APPLICATION NO.	FILING DATE	FIRST NAMED INVENTOR	ATTORNEY DOCKET NO.	CONFIRMATION NO.
10/702,506	11/07/2003	Christos Tsironis		8537

Office Action Summary	Application No.	Applicant(s)	
	10/702,506	TSIRONIS, CHRISTOS	
	Examiner	Art Unit	
	Vincent Q. Nguyen	2858

DETAILED ACTION

FIG. 8 Partly Prior Art - Cross section

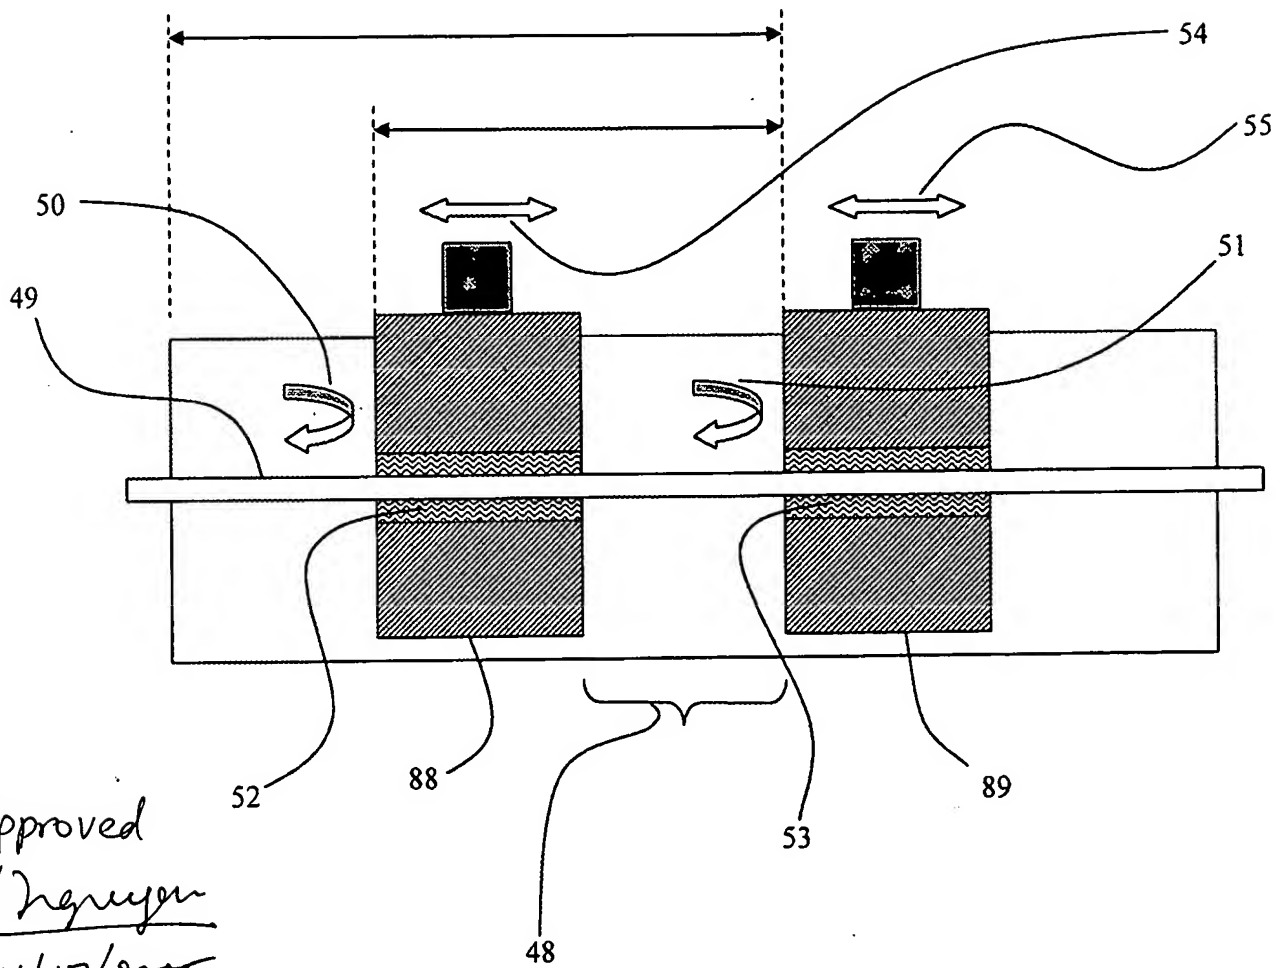
Approved
V. Nguyen
11/17/2005
